Amendment C109 Manningham Planning Scheme - Land Subject to Inundation Overlay and Special Building Overlay - Consideration of Submissions and Request for a Panel Hearing

File Number:	IN17/63
Responsible Director:	Director Planning and Environment
Attachments:	<ol style="list-style-type: none">1 Flood Mapping Catchments, 20152 Development of the Special Building Overlay Technical Report, Cardno September 20153 Planning Scheme Amendment C109 Amendment Documentation4 Consultation Report and Summary of Issues in Submissions5 Officer Response to Issues Raised in Submissions6 Template and Criteria7 Cardno Report February 20178 Peer Review, Water Technology July 20169 Summary of Submissions, Officer response and Recommendation10 Table of Recommended Changes to Submitter Properties11 Value Impact Assessment, Charter Keck Cramer, November 201612 Table of Recommended Changes to Non-submitter Properties

The purpose of this report is to consider all submissions received to Amendment C109 to the Manningham Planning Scheme.

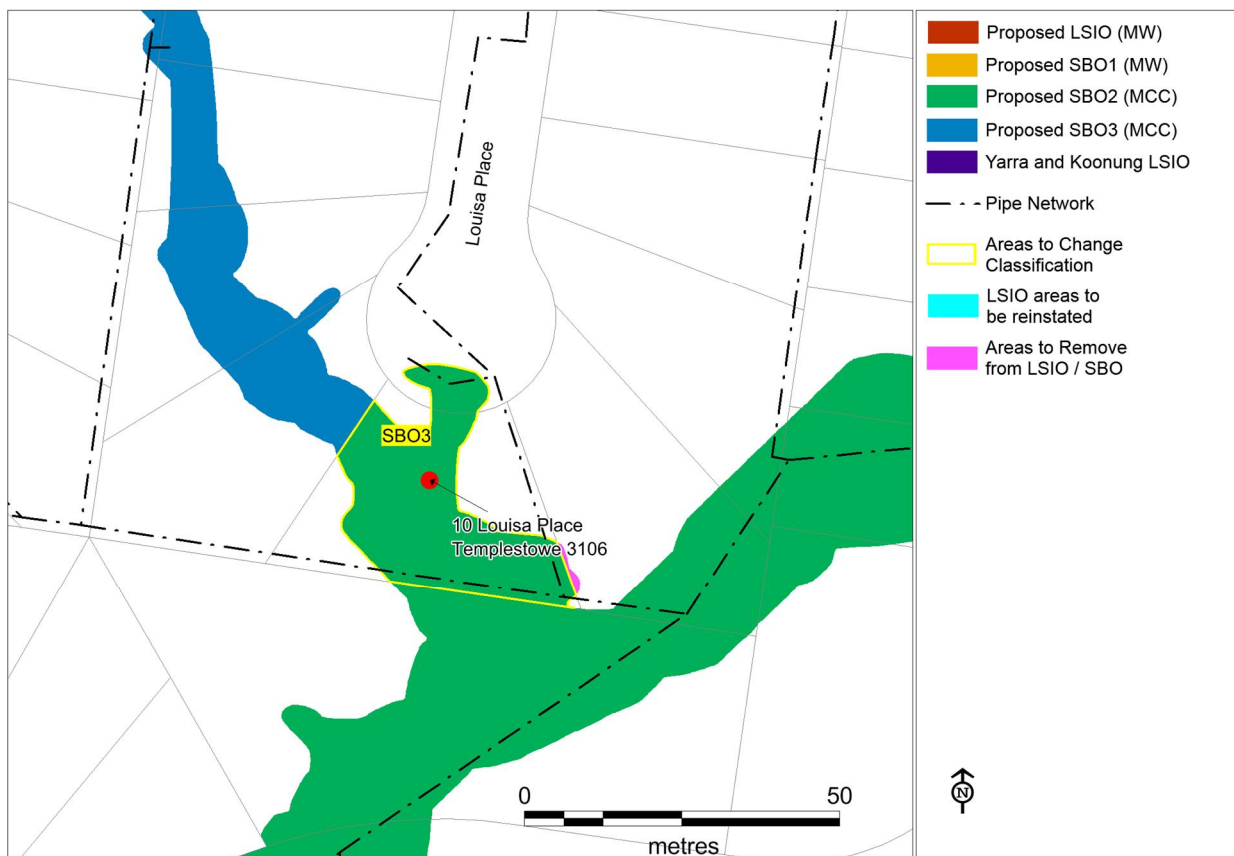
The outcome of this is that the hydraulic model results cannot include the localised information provided and the recommendation of applying the SBO will remain. However, following this review it appears that the depths across 10 Louisa Place are less than 100 mm and as a result it is recommended that the SBO be changed from SBO2 to SBO3.

Following the review of 10 Louisa Place it is noted that the historical observations are unlikely to have included an event as large as a 100 year ARI event with a critical duration of around 120 minutes.

6.3 34 Dellfield Drive, Doncaster (216)

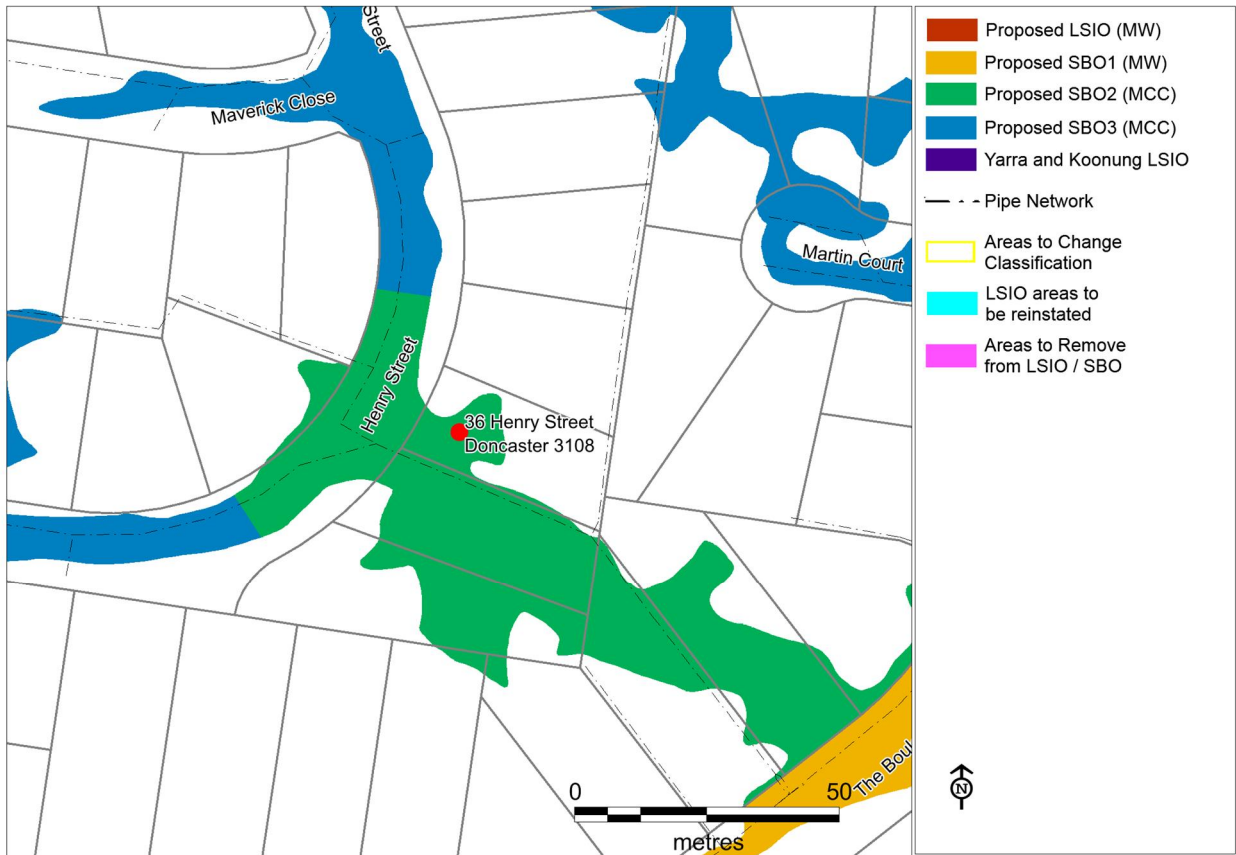
It is recommended that the SBO be retained in its current form.

Outcome: No Change Proposed

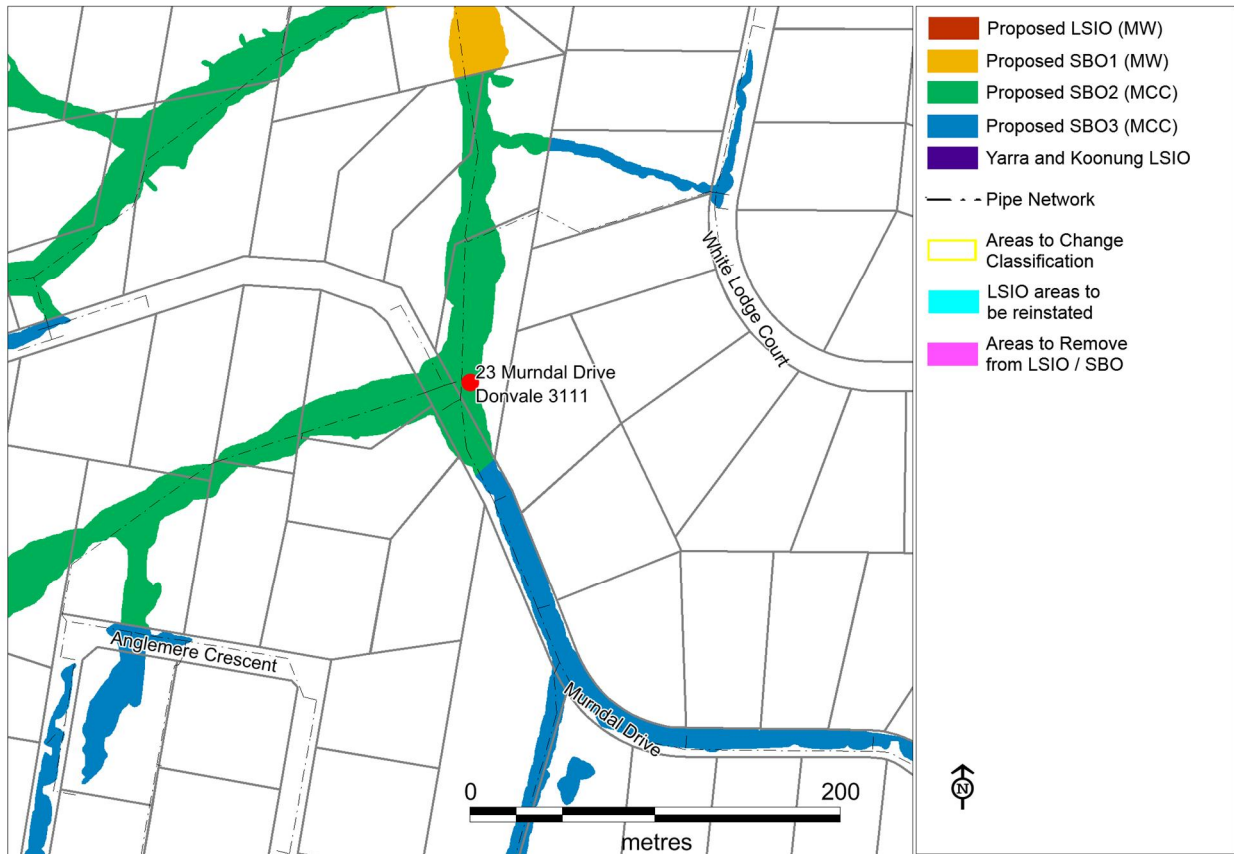
Summary of dispute: The submitter has objected to the SBO on the basis that no historical flooding has occurred and has noted local detail as evidence as to the inaccuracy of the model results.

The SBO is based on a 3m x 3m grid topography developed from 2008 LiDAR information. In addition to the topography, overland flow paths are represented with hydraulic roughness parameters which influence the runoff rates from the surface. This roughness parameter is also specified at a 3m x 3m spacing and an appropriate value is chosen to represent vegetation, gardens, retaining walls, fences, buildings etc within the model area.

Roughness is used because there is no way the full detail of the ground surface could be included within a hydraulic model covering the full Council study area due to the complexity and the changing nature of the surface. Council prefer to model the catchment this way as influencing factors on-ground often change over time as land is repurposed and developed. The intention of Council is to understand the underlying topography flow directions and flood risks they need to manage going forwards. Localised barriers to flow such as retaining walls, fences, raised garden beds etc are not treated as barriers as they can change over time. This is a well understood approach of hydraulic modelling and why the model mainly focuses on large flood events such as the 100 year ARI event.

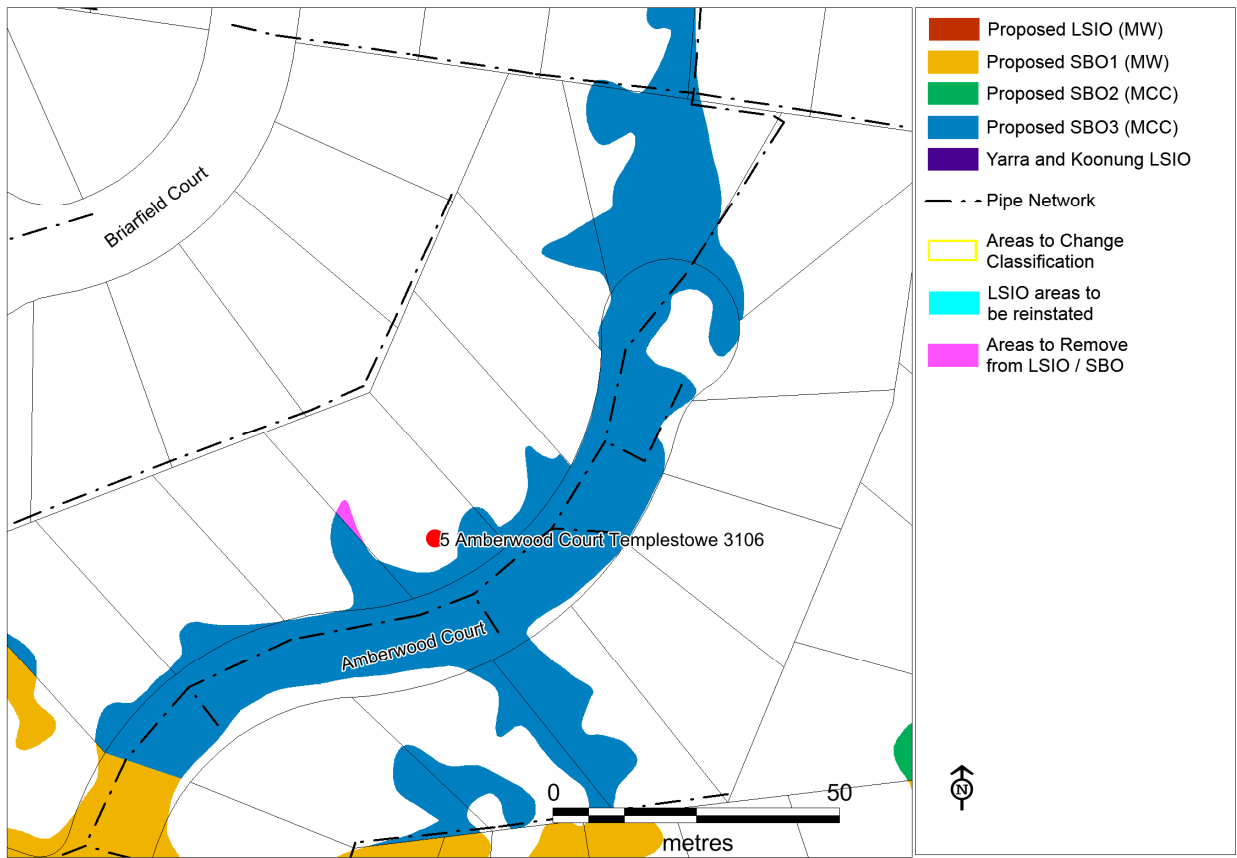
The SBO3 on the property is present as there is shallow flooding. This flooding has passed from the rear of the property to the front. It is recommended that the SBO3 remains, however the SBO3 section higher up on the site can be removed.

Outcome: No Change Proposed

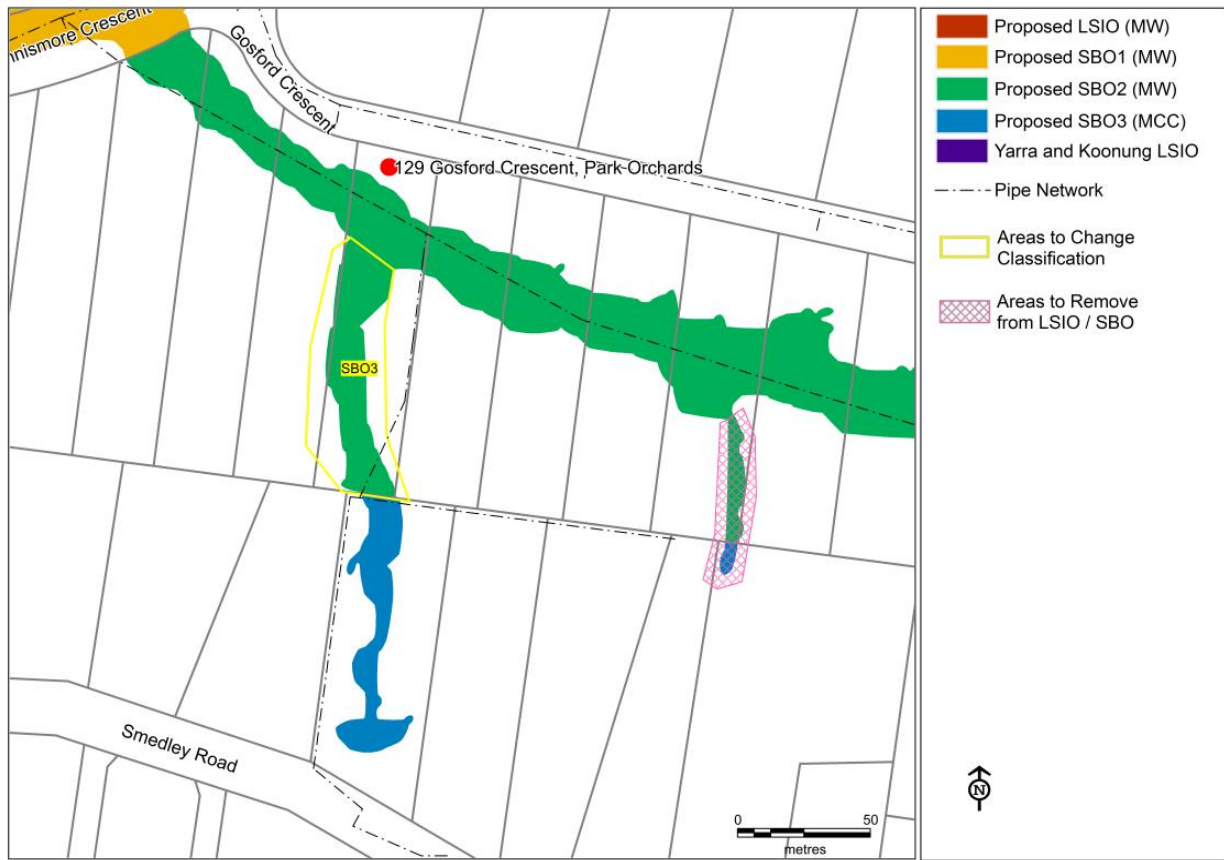
129 Gosford Crescent has two flow paths covering the property. The east-west flow path is the larger of the two with peak flood depths exceeding 1 m within the property. This area must remain under the SBO2 classification and is not in dispute.

The flow path from south to north through the site has less surface depth than the northern flow path. Whilst a small portion of this flow path has depths greater than 100 mm for the 100 year ARI event, overall it is less than this. Consequently, it is recommended that this is changed from SBO2 to SBO3.

Furthermore, there is a small additional flow path to the east at 133-115 Gosford Crescent. This flow path has been automatically connected to the major flow path during the processing stages of this project even though it is very a small localised ponded area. If the join had not happened, the ponded areas would have been less than 500m² and therefore removed from the flood extent.

6.10.1.7 *Dispute Item 7*

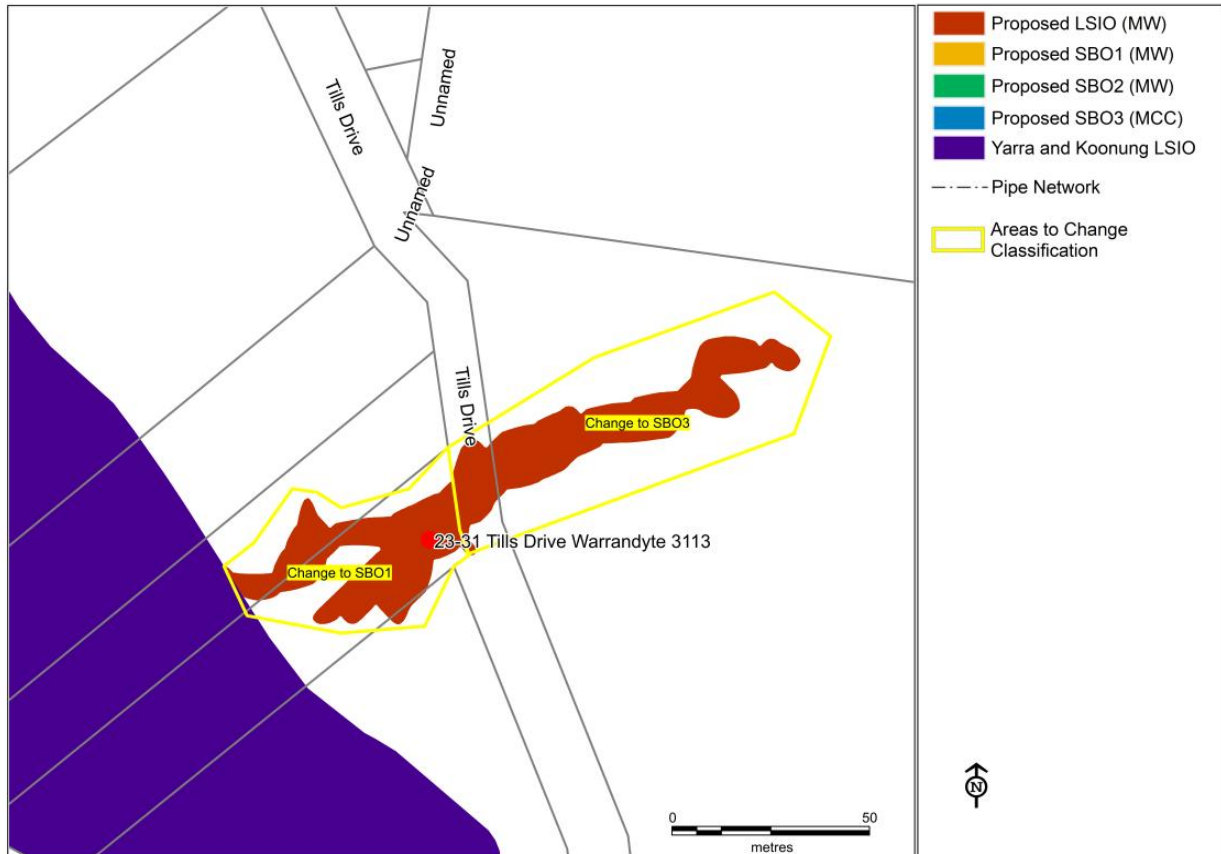
Summary of dispute: Council inquired why the proposed LSIO should not be an SBO instead.

Due to its proximity to the Yarra River, Melbourne Water requested that this area be under its control. It was then designated as an LSIO area as there are no underground assets in this location. However if Council and MW can agree to convert this to Council controlled, it is recommended that it become SBO1.

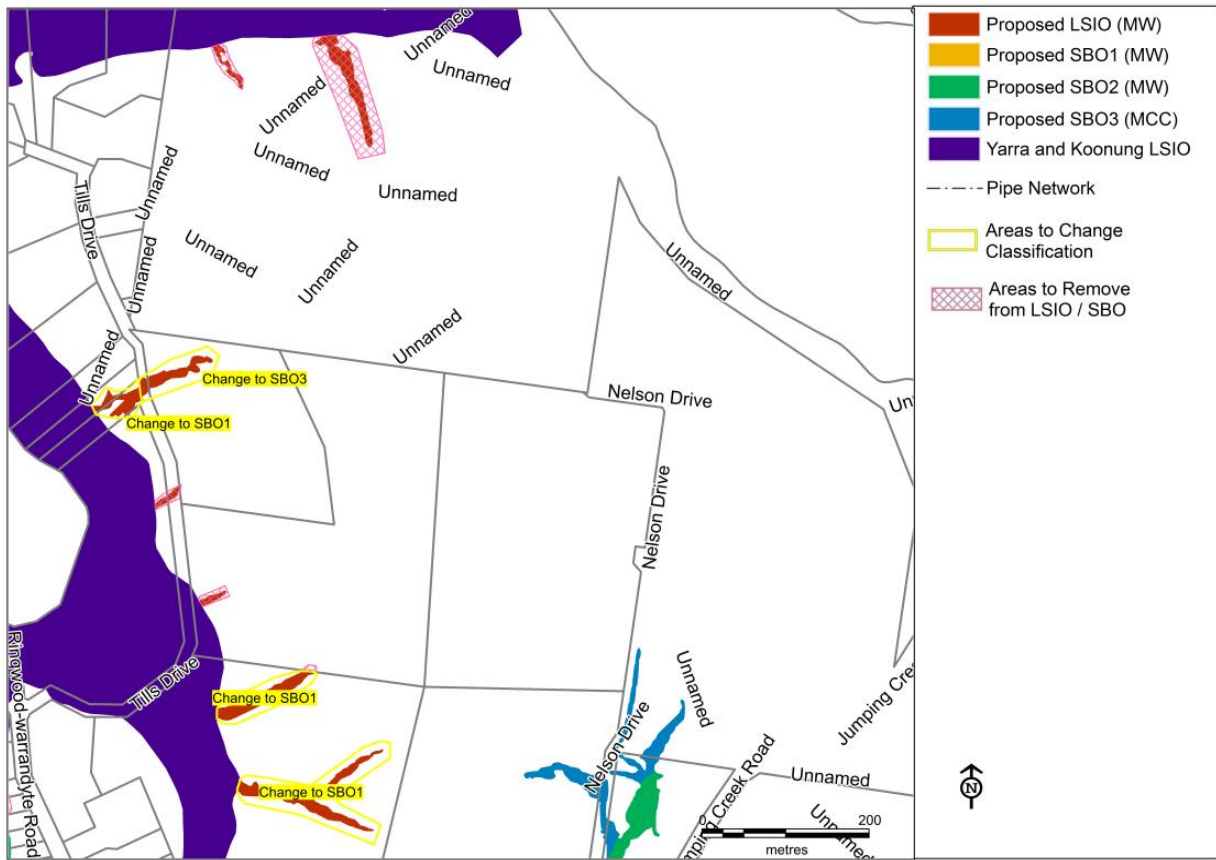
Further to the advice above, MW have also requested changes to several other similar flood extents within the same area. These are shown in the figure below.

Outcome: Make changes above as requested by Melbourne Water

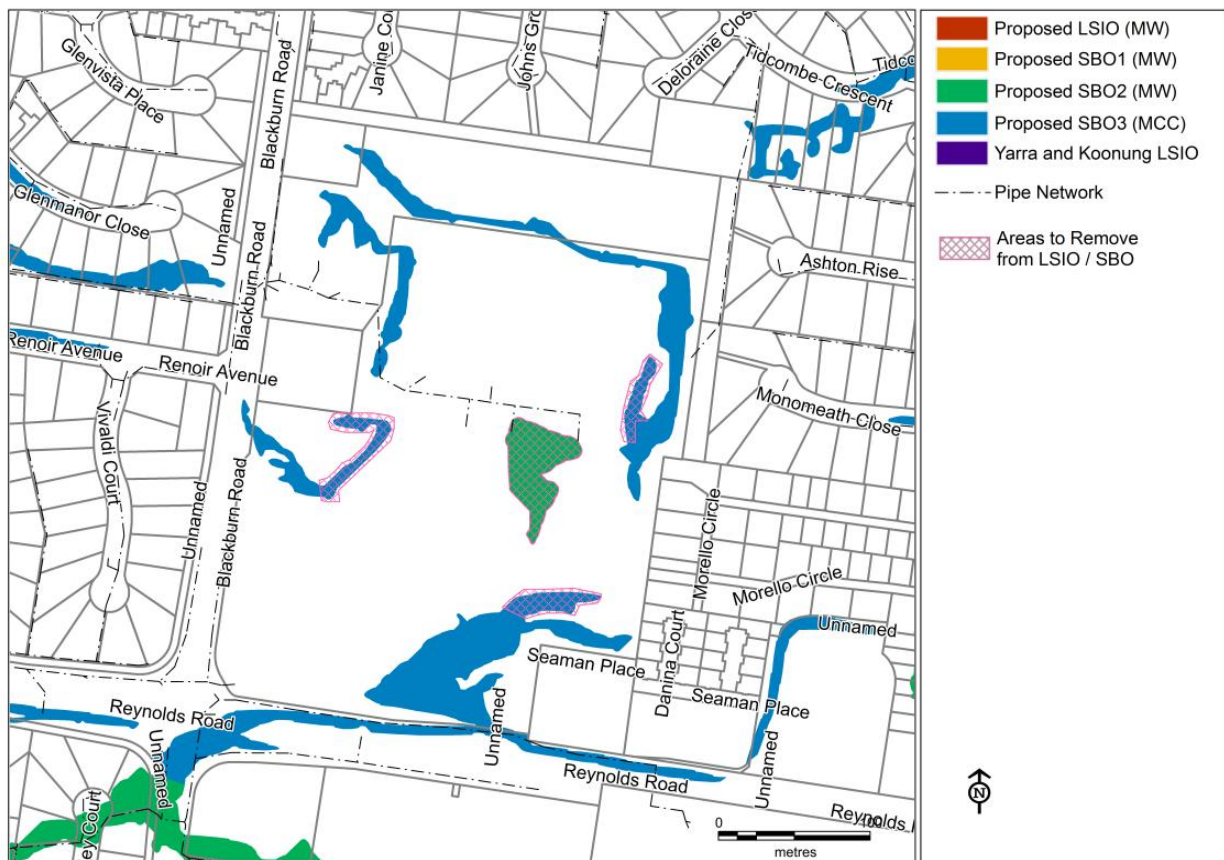
Submitters Concerns	Response
The property consists of major roofs and flow paths sit on top of these, in particular Target where there is an SBO2 proposed.	It is recommended that the SBO be removed from the roofs of the buildings
There are flow paths which would not occur as there is an extensive drainage system within the site.	Private drainage infrastructure has not been considered. This is a blanket rule that has been applied across the full municipality. The reasoning for this is Council cannot guarantee that the private drainage infrastructure is appropriately constructed and maintained. The only Council infrastructure on the property is a 375 mm pipe.

Outcome: Remove SBO from buildings as shown

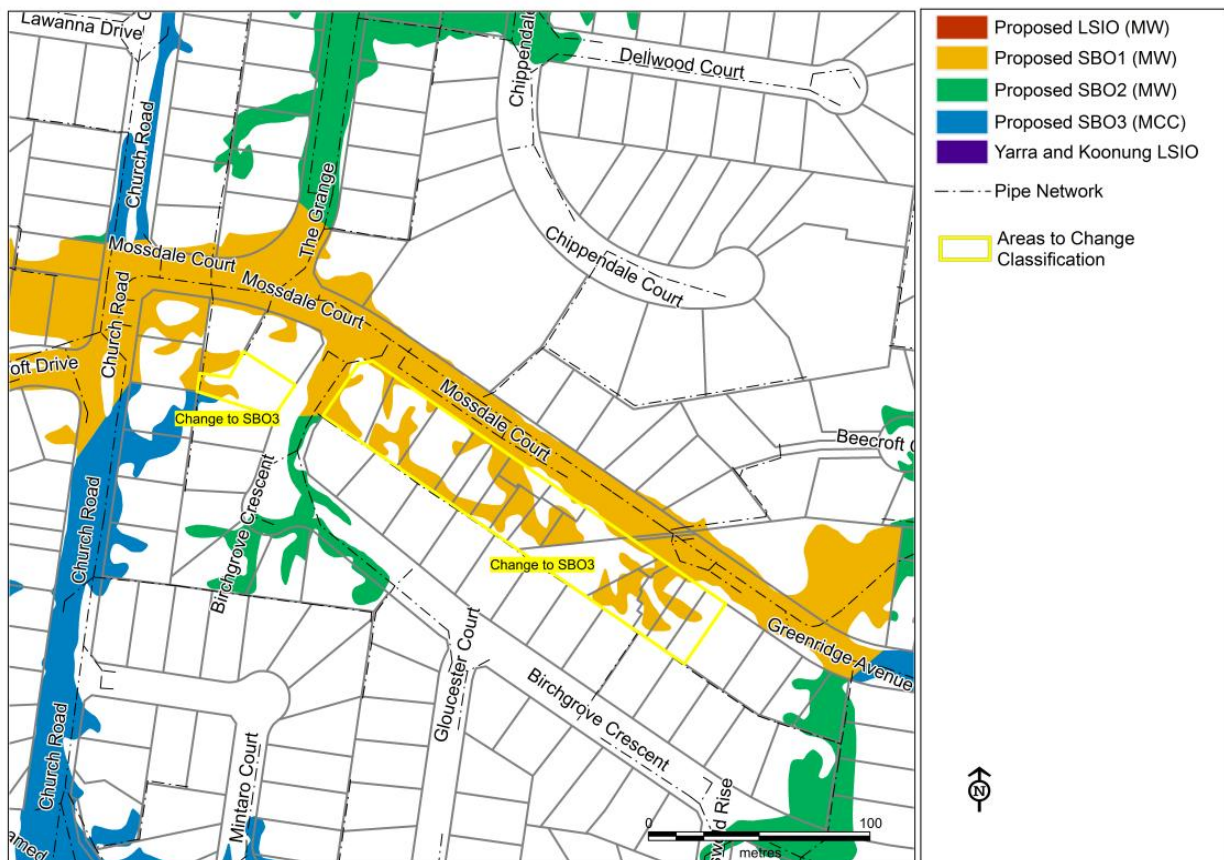
Submitters Concerns	Response
<p>The SBO is appropriate along the main road, however it is not suitable on the steep paths that lead to the road as these are shallow (and fast).</p>	<p>The SBO picks up both deep flow and fast flowing sheet flow. This is entirely appropriate. It should be noted that this model is not rainfall on grid, therefore the source of the water is from flows surcharging from the stormwater network at the rear of properties and flowing toward Mossdale Court. If Melbourne Water and Council can agree, it is recommended that the small flow paths from the properties adjoining Mossdale Court are converted into SBO3 (from SBO1).</p>

Outcome: Change areas from SBO1 to SBO3
